Re: ZC Case 06-03 -- 100 M Street, S.E.: Request for Minor Modification of Plans the Zoning Commission Previously Reviewed and Approved under Provisions of the Capitol Gateway Overlay

**100 M STREET S.E.**  
**WASHINGTON, DC**  
**OFFICE BUILDING**  
**REQUEST FOR MODIFICATIONS - ZONING**

INDEX	BOARD OF ZONING REQUEST FOR MODIFICATION SET (02/28/07)
COVER	INDEX
L-1	ORIGINAL LANDSCAPE PLAN RENDERING
L-1R	REVISED LANDSCAPE PLAN RENDERING
A-3	ORIGINAL FIRST AND SECOND FLOOR PLAN
A-3R	REVISED FIRST FLOOR PLAN
A-6	ORIGINAL PENTHOUSE - ROOF PLAN
A-6R	REVISED PENTHOUSE - ROOF PLAN
A-11	ORIGINAL EAST ELEVATION
A-11R	REVISED EAST ELEVATION
A-12	ORIGINAL WEST ELEVATION
A-12R	REVISED WEST ELEVATION

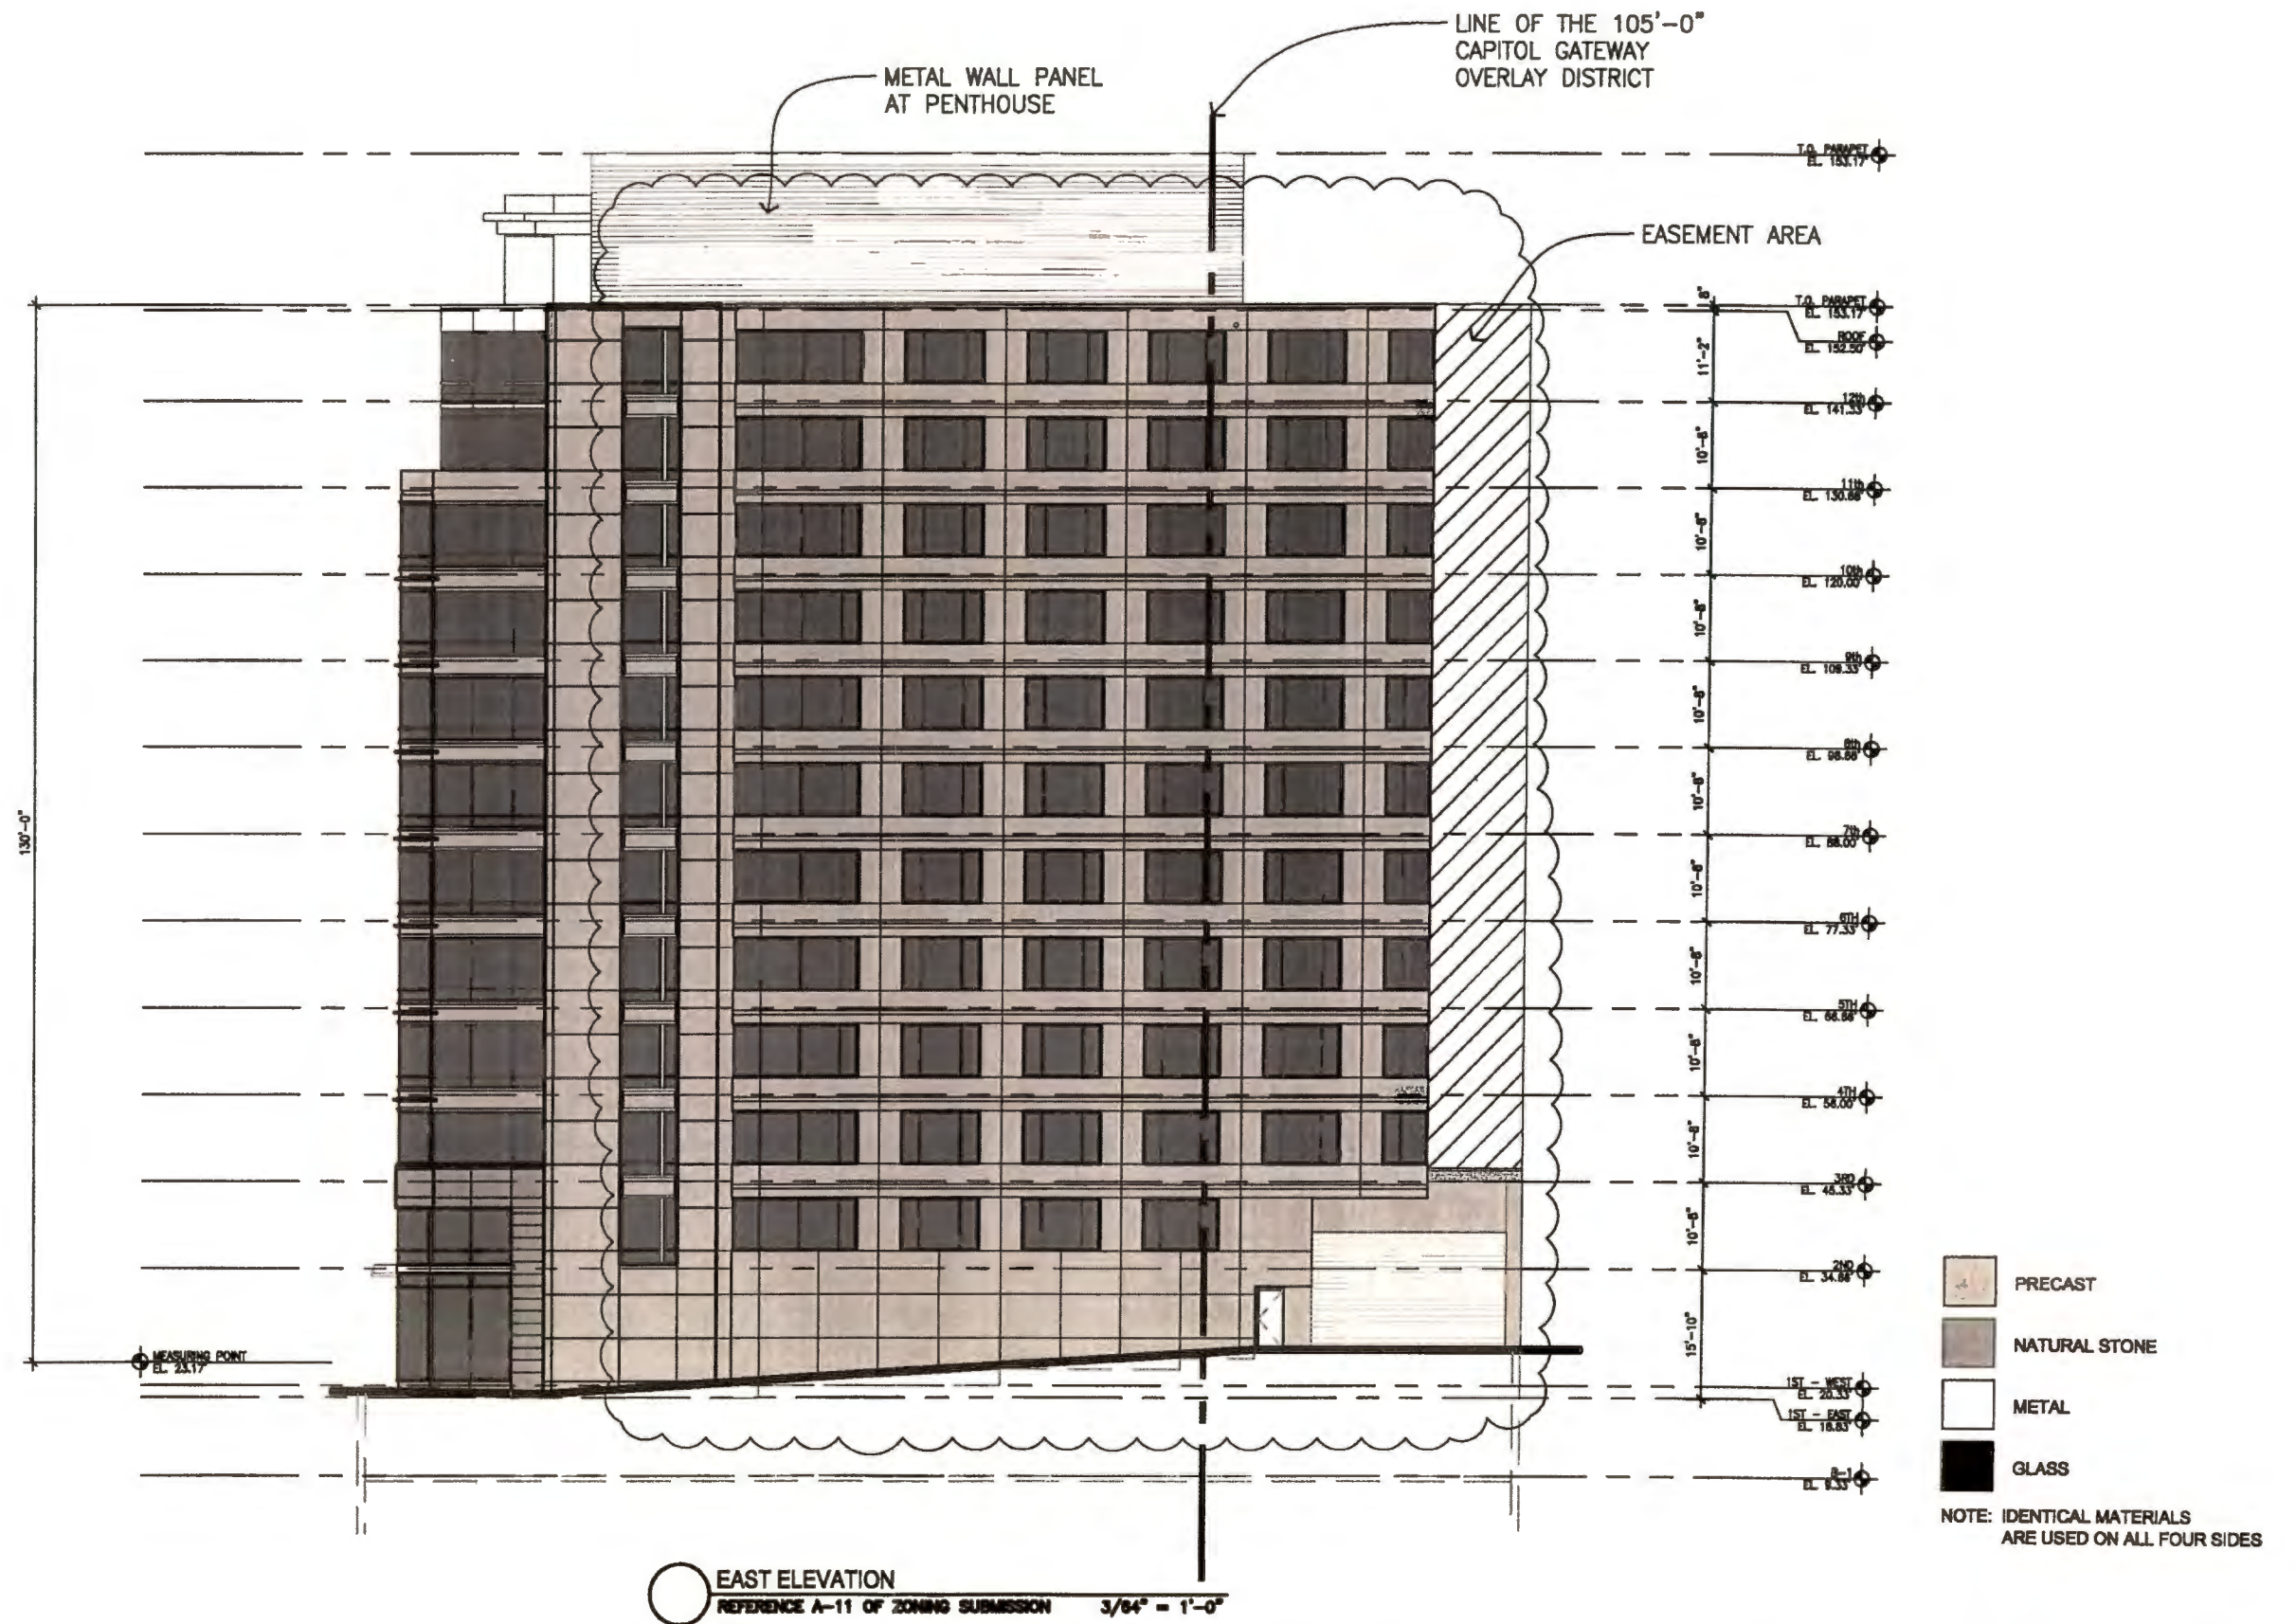
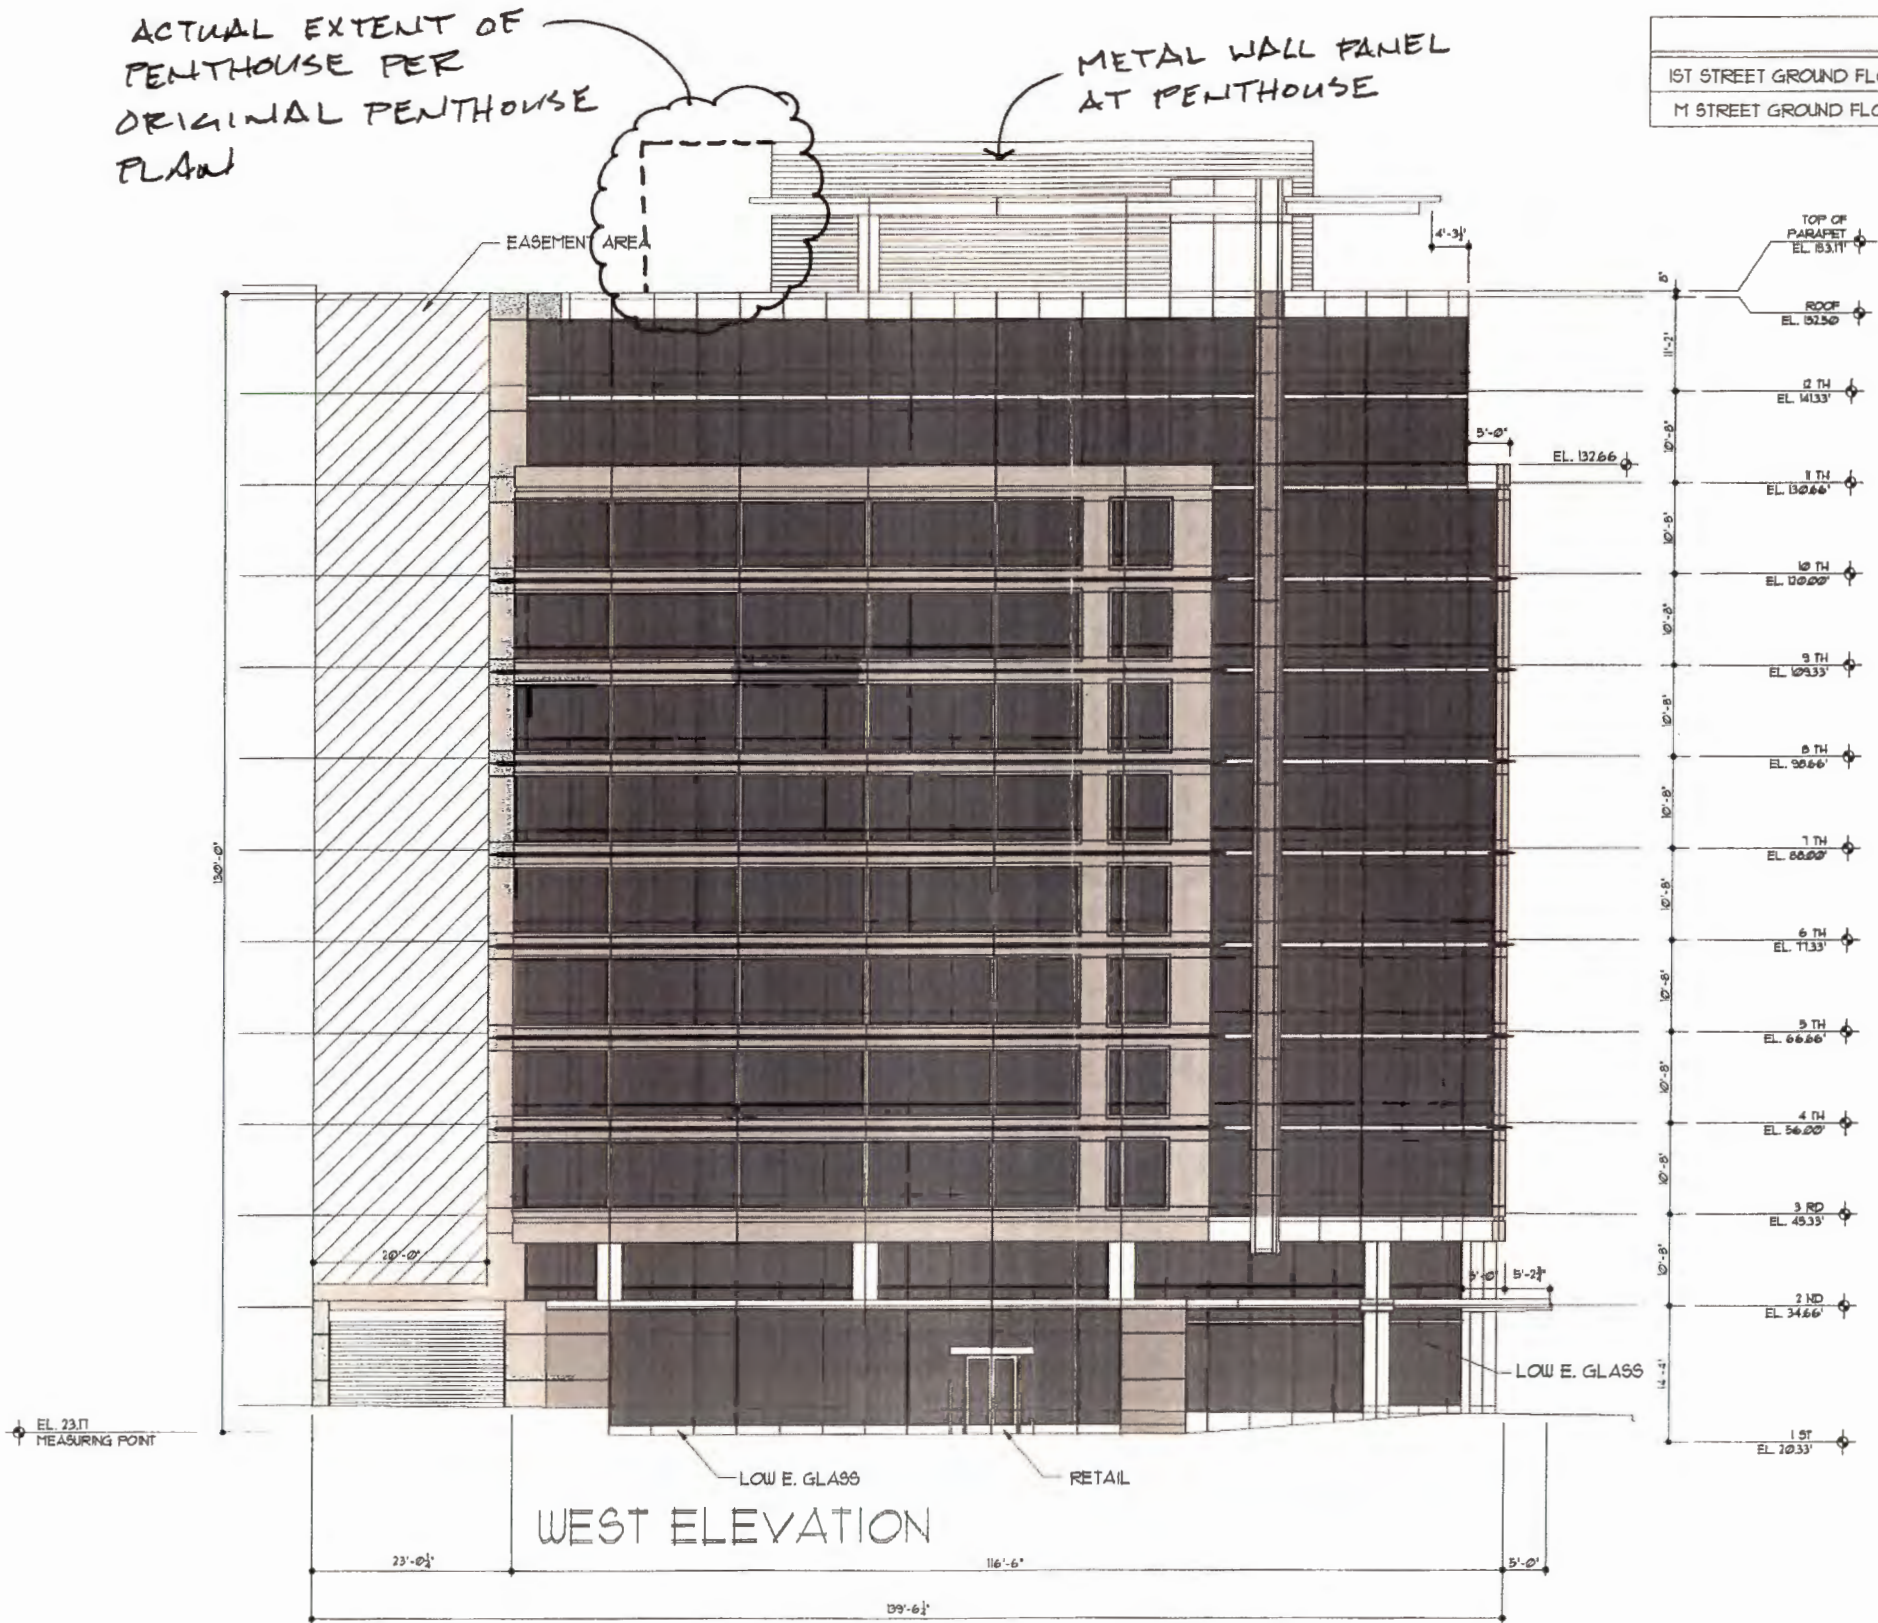
### 3. **Minor Modification to Percentage of Glazing on Eastern Face of Building**

Plan review within the Department of Consumer and Regulatory Affairs revealed that the eastern face of plans called for about fifty two percent of the side to be glazed. This portion of the site abuts another property, currently undeveloped. The applicable regulations limit such openings to forty five percent (45 %). The **minor modification requested** reduces glazing so that it complies with this standard.
